Grove City Area School District High School Renovations

Project No: 23-S43-01

ADDENDUM 4

3/21/2024

1 FIRST FLOOR PLAN - AREA B
A102 1/8" = 1'-0"

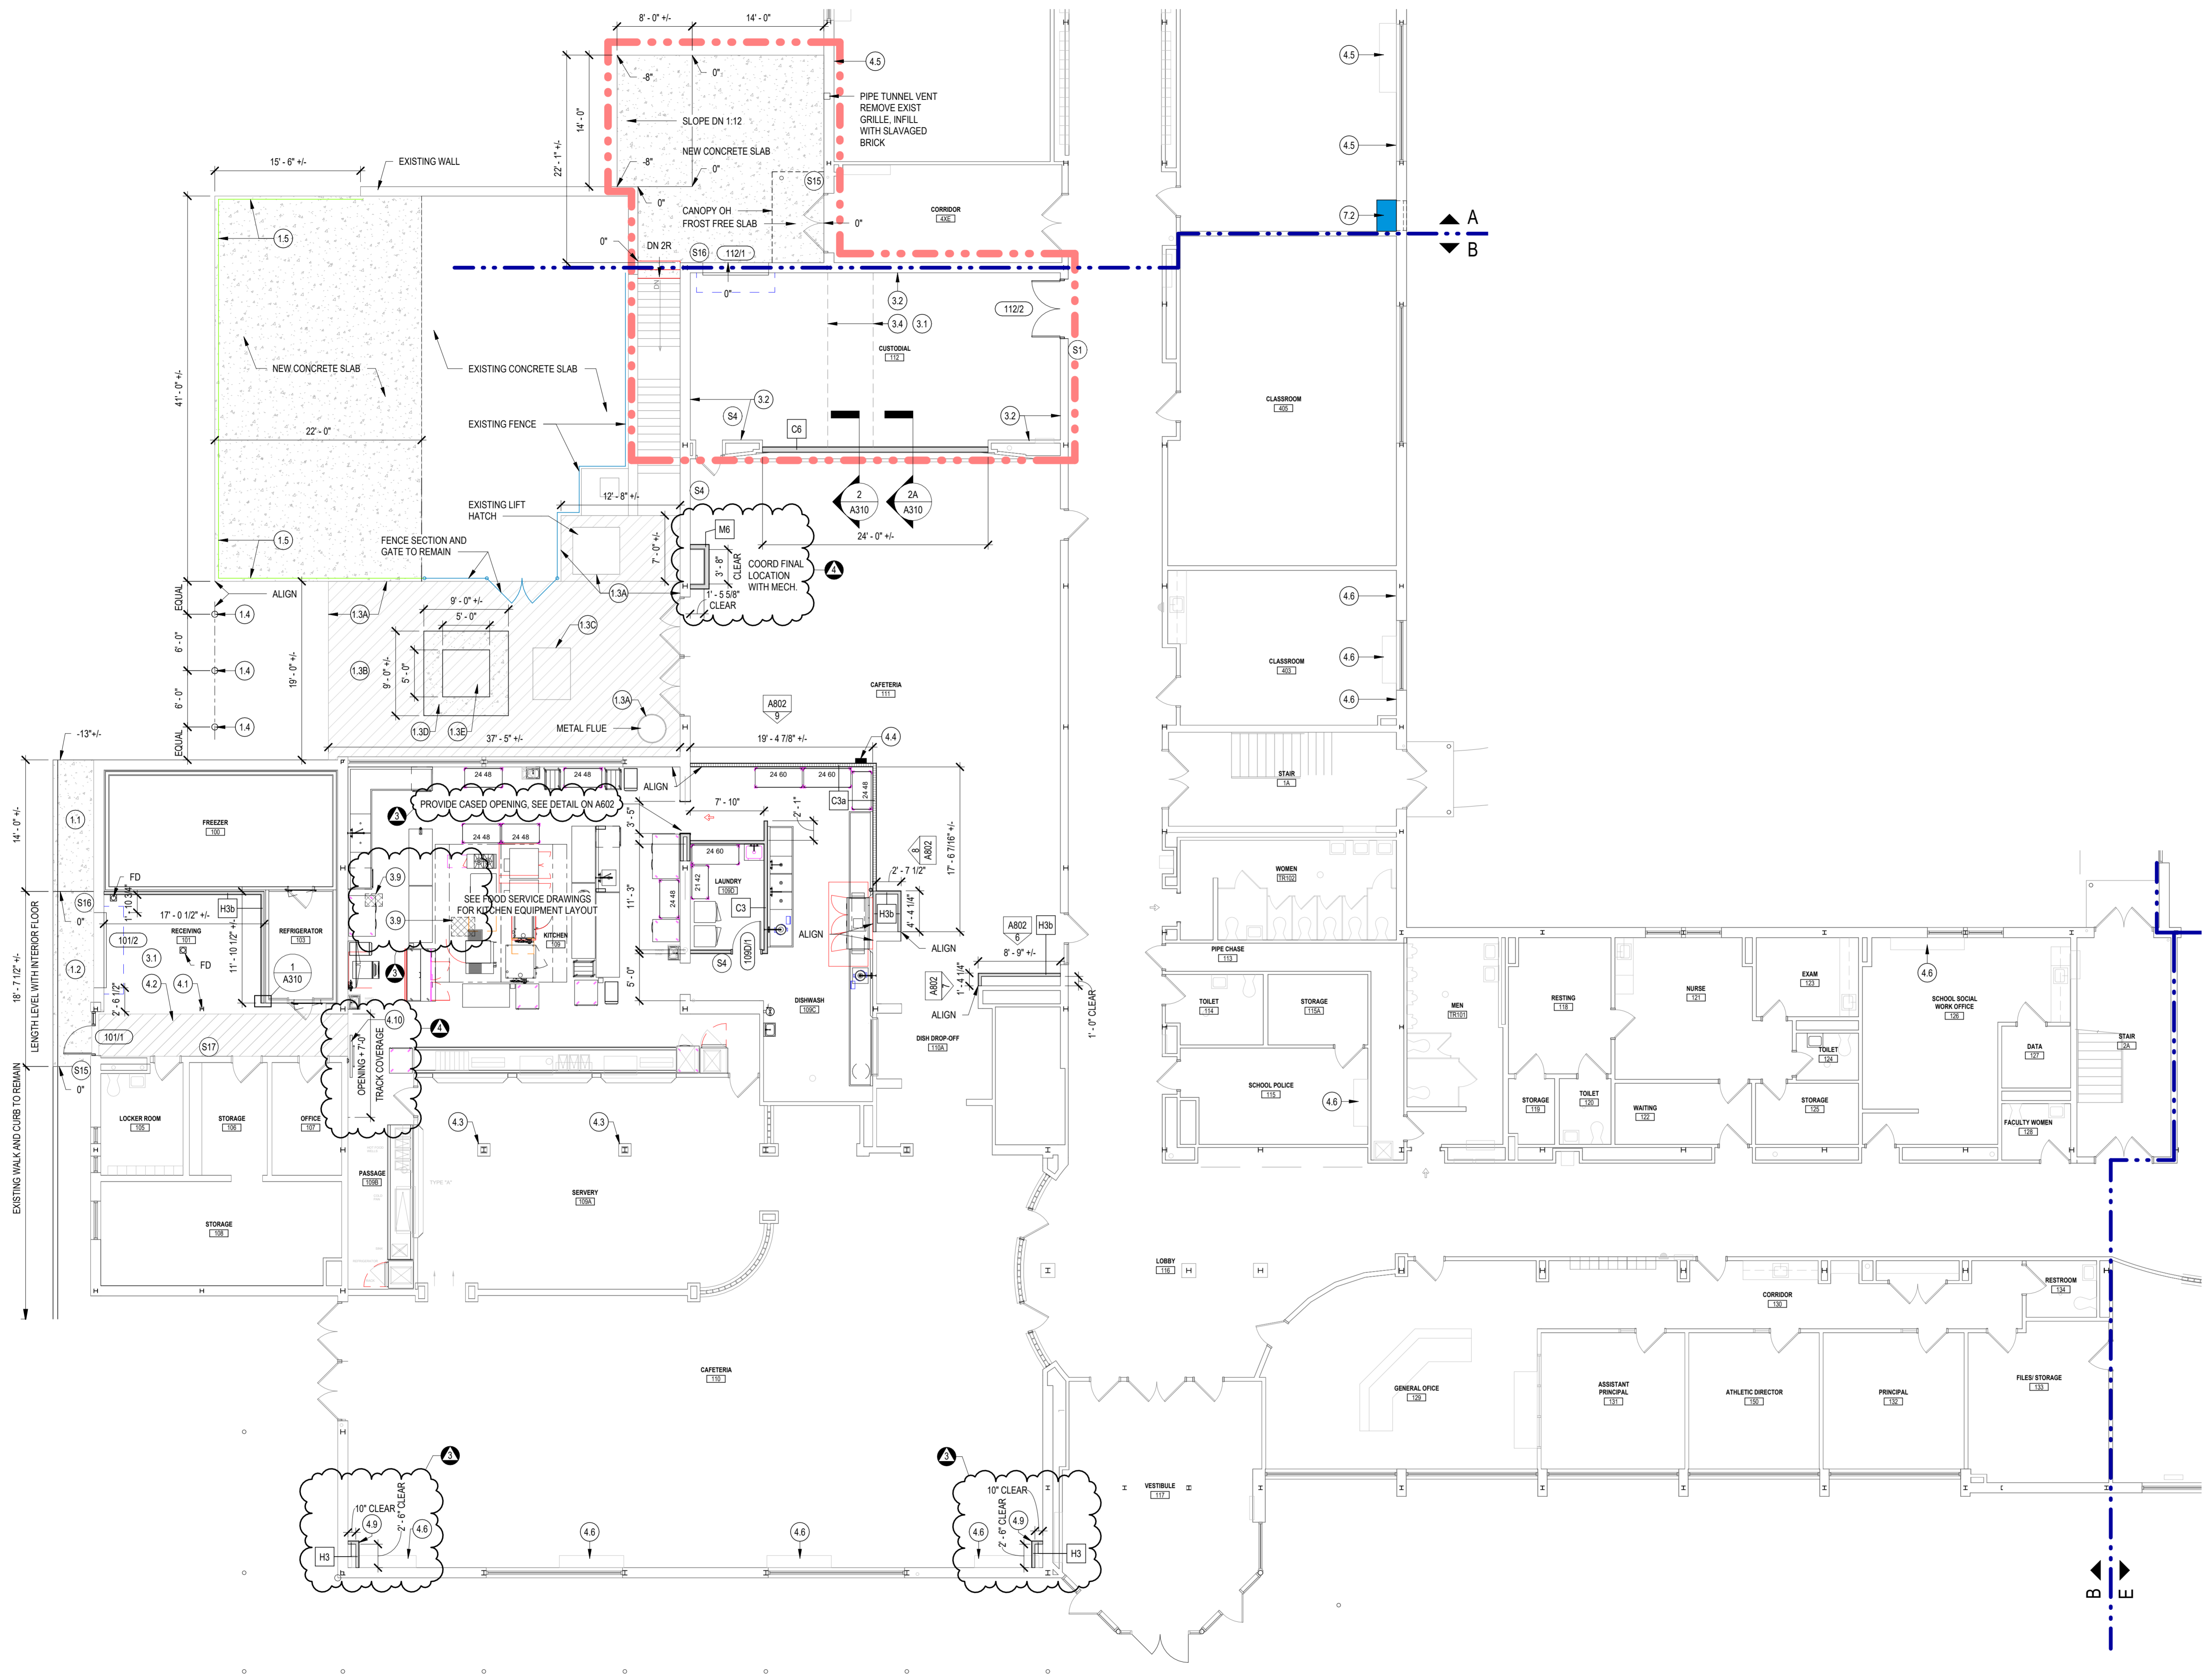
Sheet	Detail	Comments
A001	Legends, Abbreviations, General Notes, and Partition Types	Added wall type M6
A101	First Floor Plan – Area ‘A’	Refined Receiving concrete slab design
A102	First Floor Plan – Area ‘B’	Added sliding PVC curtain to opening between Receiving 101 and Kitchen 109. Added chase to Cafeteria 111
A106	First Floor Plan - Area ‘F’	Added pipe chases to Classroom 163 and Planning 310 Removed unit ventilator from Classroom 163 Changed unit ventilator notes in Classroom 163 to coordinate with new units per mechanical design.
A311	Wall Sections and Details	Modified Section 1 to incorporate linear diffuser. Added Section 2A – Window Closure Section
A601	Door Schedules, Door and Frame Types, Frame Details	Corrected materials in Door Schedule Added masonry return note to new OH doors Modified View Window dimensions
A602	Door and Window Frame Details	Added masonry return detail
A702	First Floor Reflected Ceiling Plan – Area ‘B’	Added bulkhead between Receiving 101 and Kitchen 109

1 BASEMENT FLOOR PLAN - AREA 'B' - MECHANICAL NEW WORK
Scale: 1/4" = 1'-0"
FIRST FLOOR ELEVATION 1252'-0"

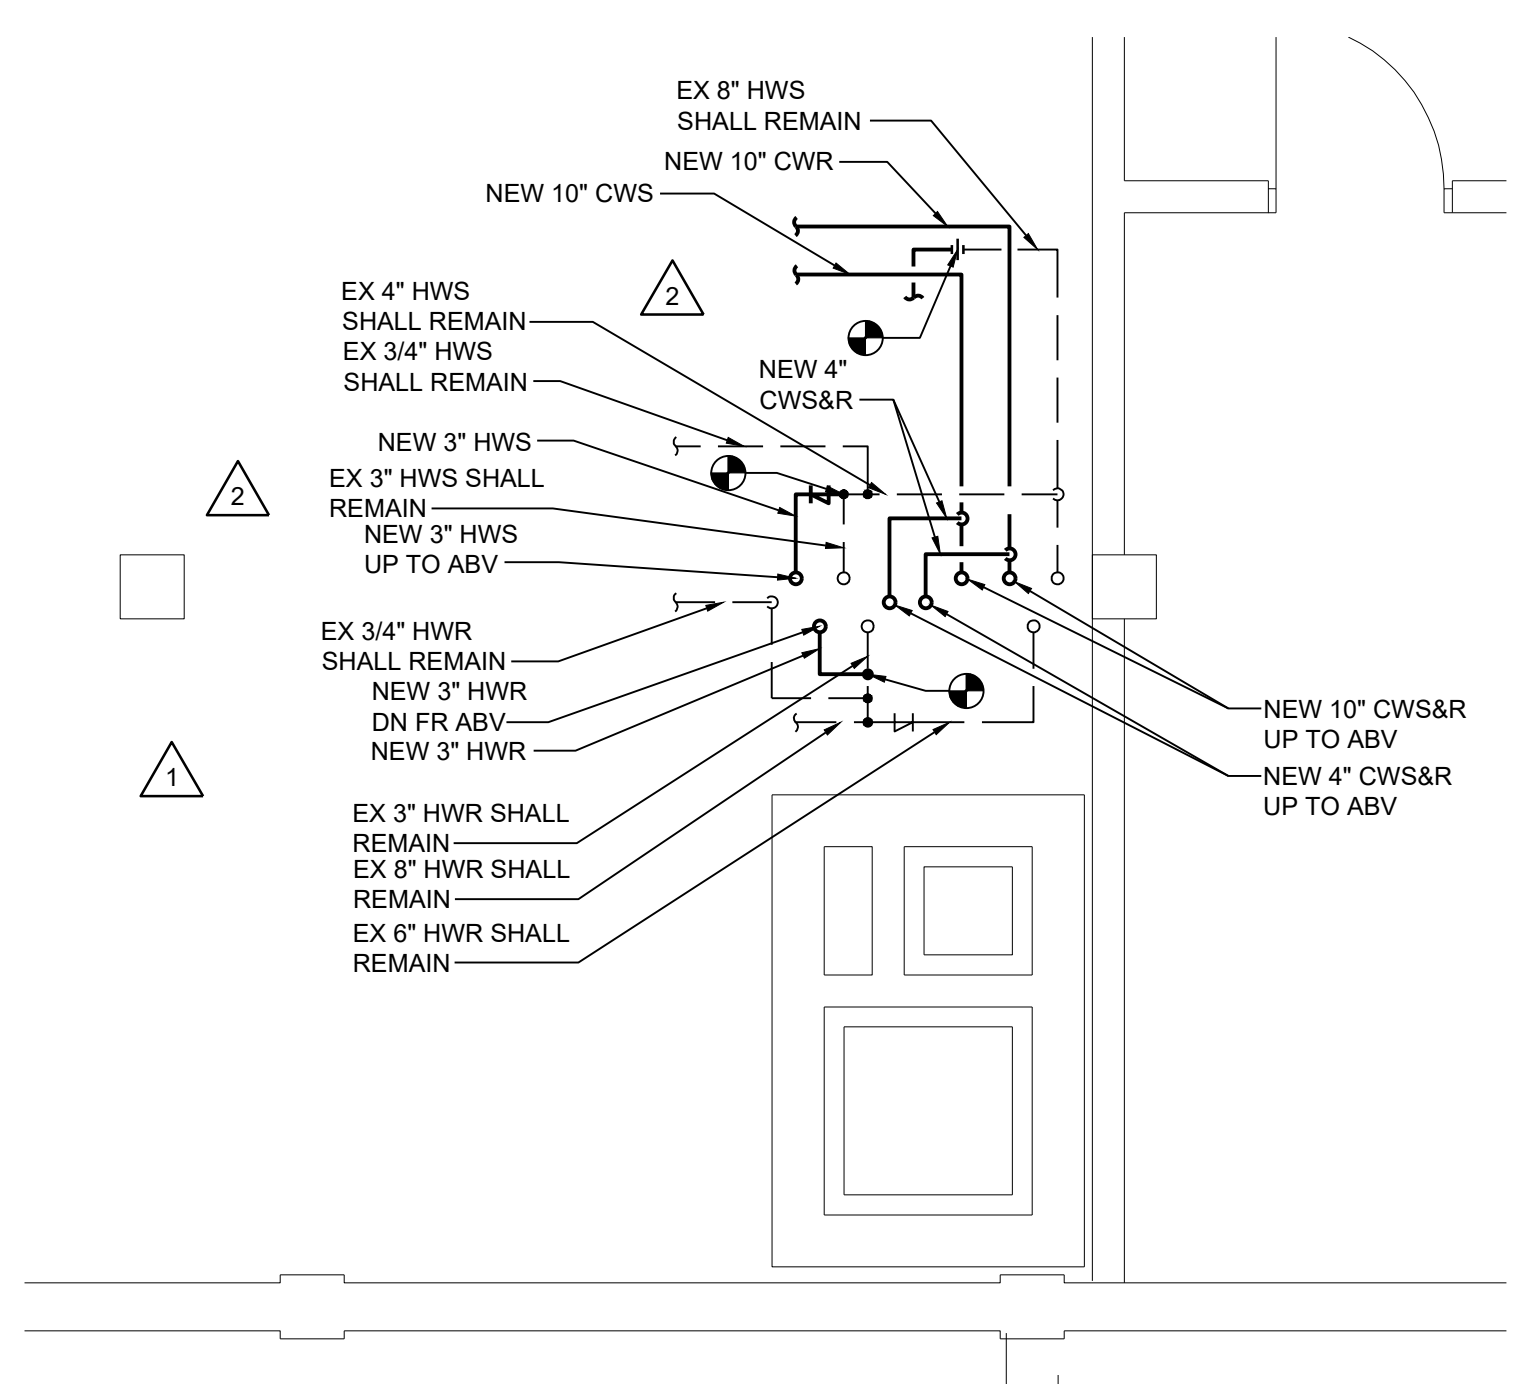
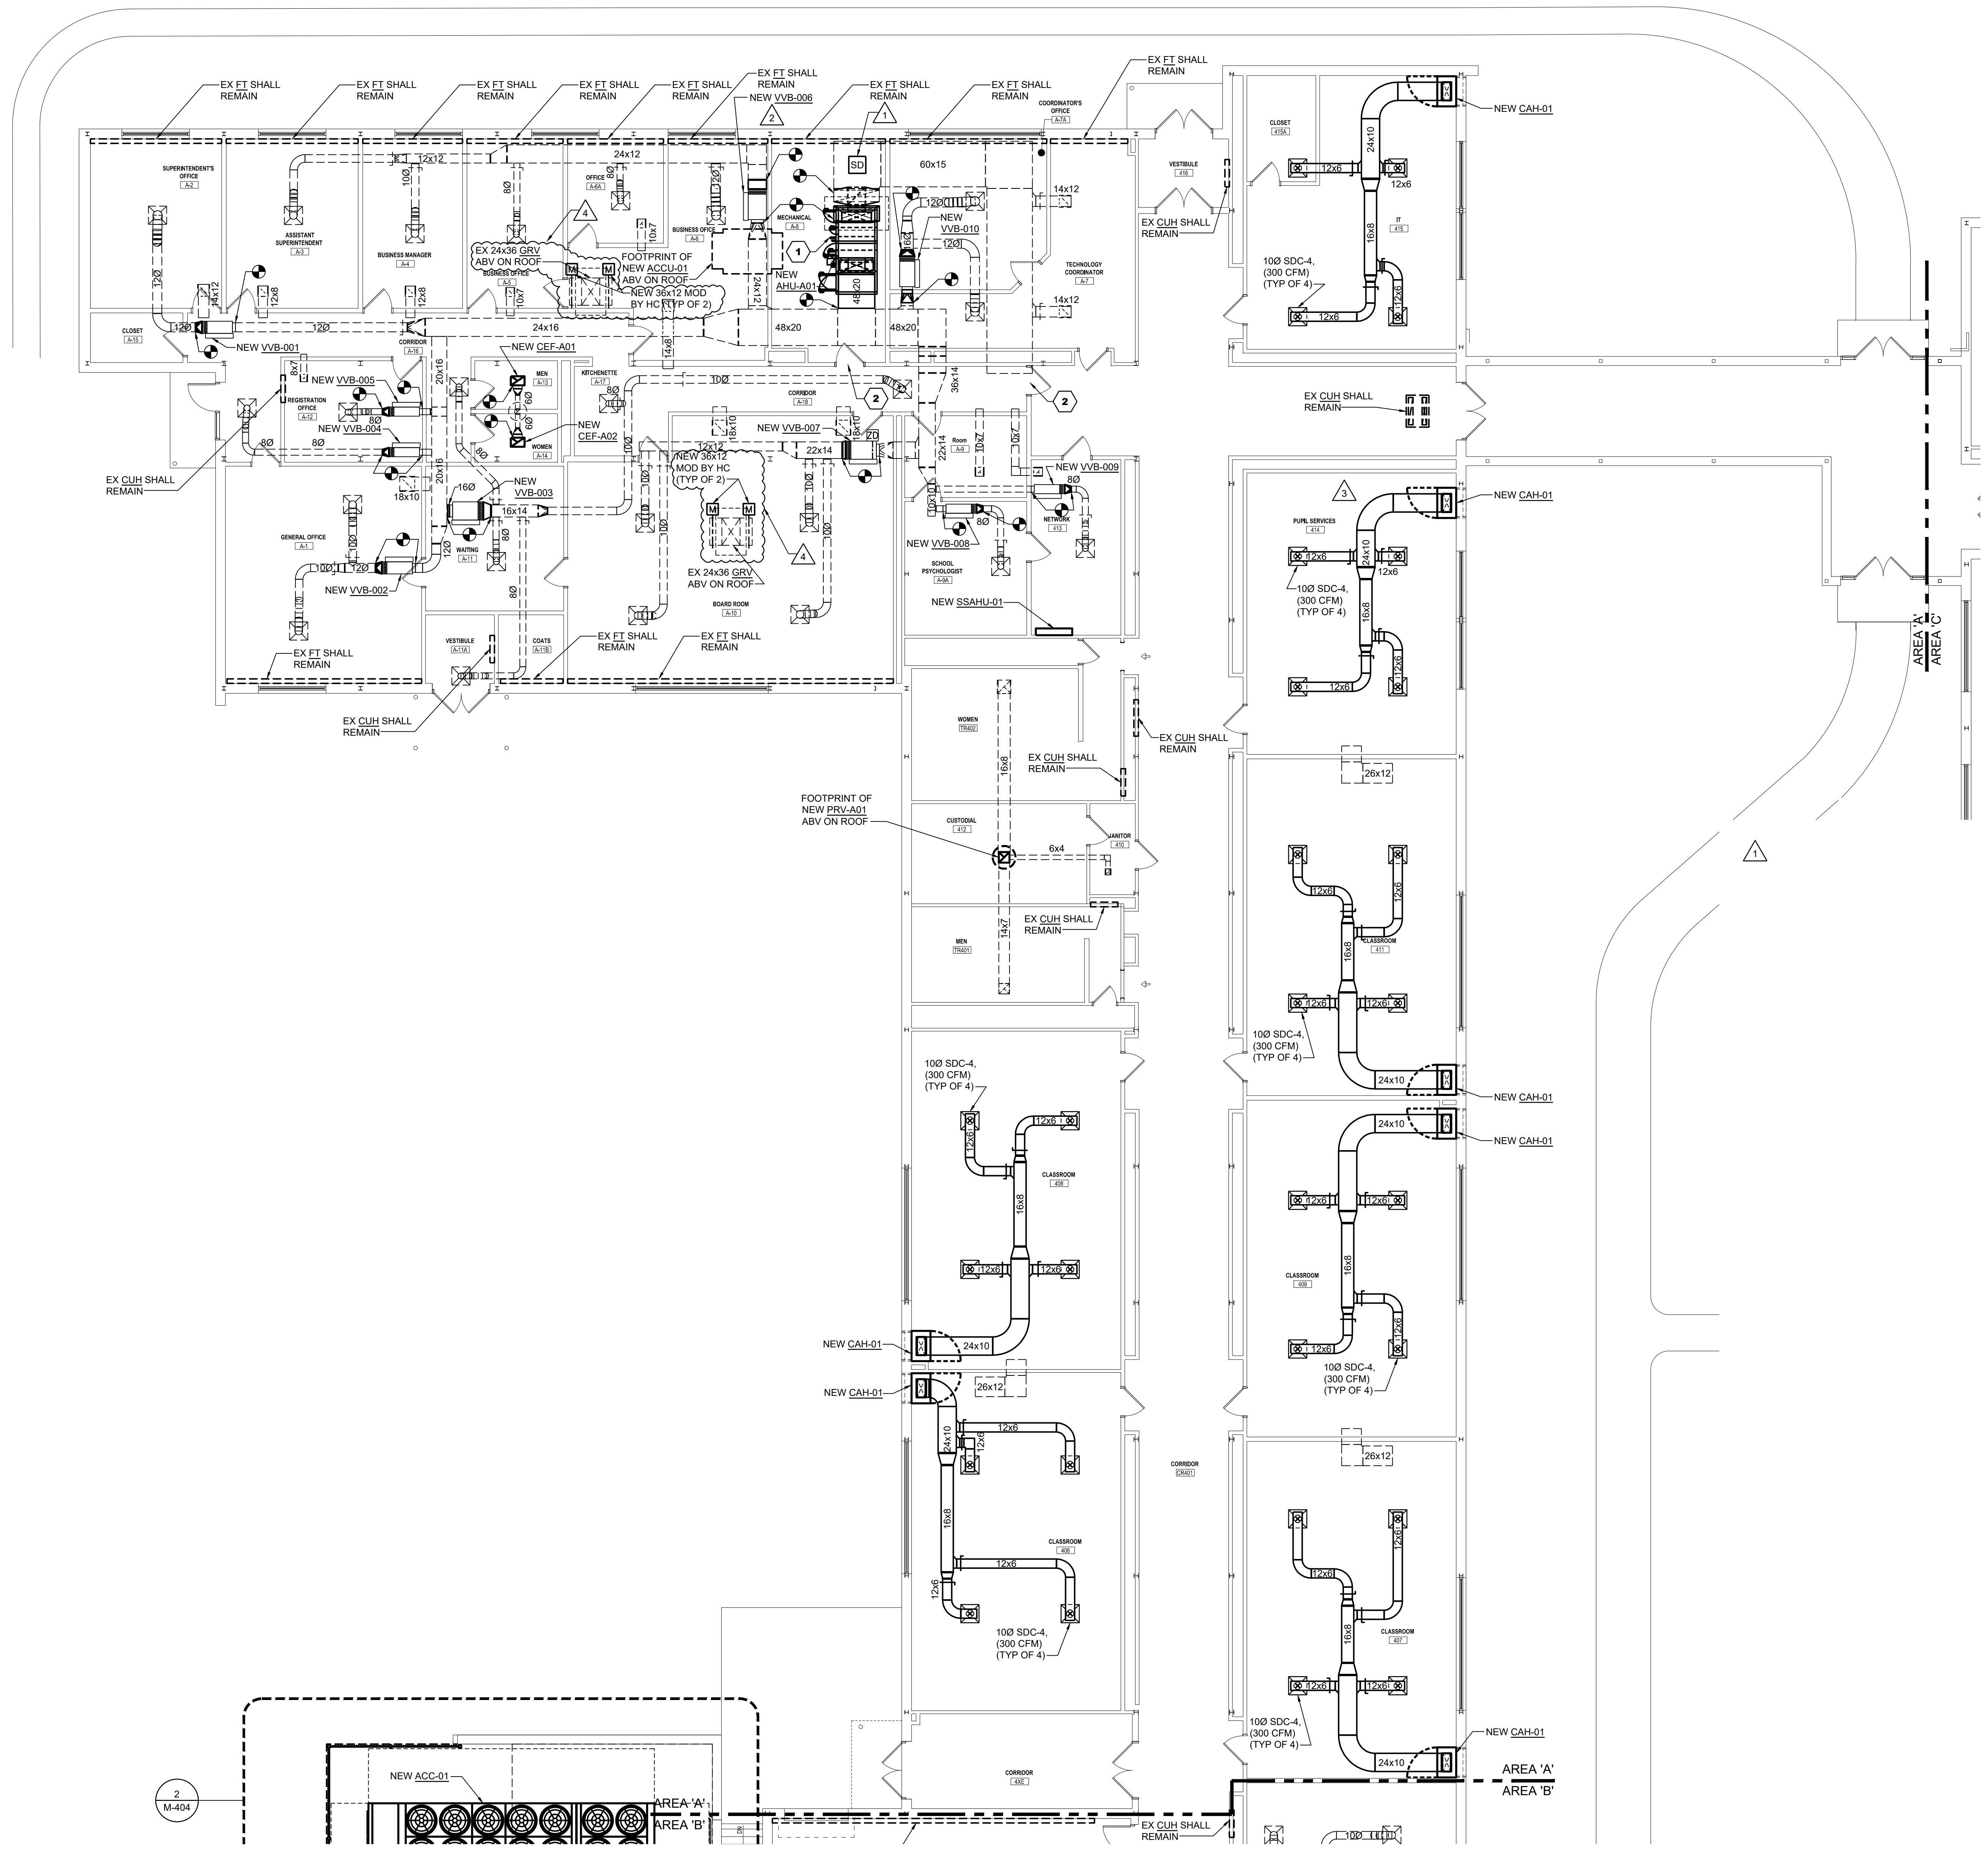
M100	Area B Basement - New Work	Added refrigerant detection system, refrigerant vent, and refrigerant exhaust system.
M101	Area A 1st Flr - Ductwork New Work	Added GRV backdraft damper replacement notes.
M102	Area B 1st Flr - Ductwork New Work	Added GRV backdraft damper replacement notes and refrigerant vent pipe and refrigerant exhaust ducting.
M103	Area C 1st Flr - Ductwork New Work	Added GRV backdraft damper replacement notes.
M104	Area D 1st Flr - Ductwork New Work	Added GRV backdraft damper replacement notes.
M105	Area E 1st Flr - Ductwork New Work	Added GRV backdraft damper replacement notes.
M106	Area F 1st Flr - Ductwork New Work	Added GRV backdraft damper replacement notes, kiln ventilation systems, and Tech Ed lab exhaust systems.
M108	Area B 2nd Flr - Ductwork New Work	Added GRV backdraft damper replacement notes.
M109	Area E 2nd Flr - Ductwork New Work	Added GRV backdraft damper replacement notes.
